Land at Bird in Eye Farm – Consultation Response to Application WD/2024/1799/MAO and Written Representations to Appeal APP/C1435/W/24/3356658

- 1.4 This letter sets out our review of this revised access strategy and access arrangement. We consider the extent to which the substitute access arrangement and the various additional supporting information submitted by the Appellant to PINS on 9 May 2025, addresses the objections outlined in our Client’s letter of 10 February 2025.

Figure 1: Comparison of Access Arrangements

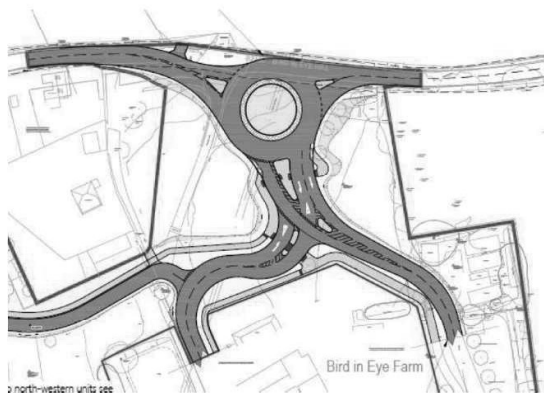
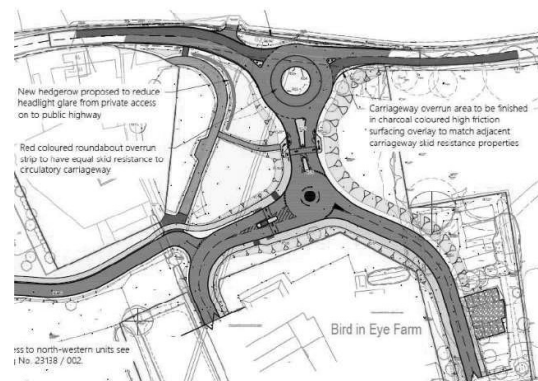
- (f) Third, our Client's letter of 10 February 2025 noted that significant earthworks are required to deliver the proposed junction design, with embankments shown on some drawings. However, no detailed information on the required earthworks is provided within the Application or Appeal material and no detailed information on the levels/ carriageway gradients is provided. This concern is exacerbated in respect of the substitute arrangement which shows more extensive embankments/ build ups as part of the access arrangement on Drawings **23138/001 Rev J** and **23138/006 Rev H**. However, no further information on the required earthworks and the potential impact of those has been provided by the Appellant. The comparison of the original and substitute access arrangements at Figure 1 demonstrates this increased prominence of earthworks clearly with the areas shaded in green.

- (j) Finally, access to plots 18 and 19 Bird in Eye Hill is taken from within the Appeal Site via a convoluted access route leading north from the Bird in Eye Farm/North west plot access road. This is clear from the comparison of the original and substitute proposals included at Figure 1 of this letter which shows much greater hardstanding in the substitute proposals now being put forward by the Appellant in this location. The route shown as a single track bonder gravel drive is not wide enough for two vehicles to pass and only a single passing place is provided which would not be visible by a driver entering the drive from the internal access road. The arrangement appears constrained and is a further demonstration of how the over-engineered access arrangement has been compressed into the limited area available. In addition, pedestrian access to Plots 18 and 19 is far more constrained in the substitute access arrangement now proposed for any pedestrians seeking to access to or from the north east of the proposed development who are now required to traverse the new access layout.
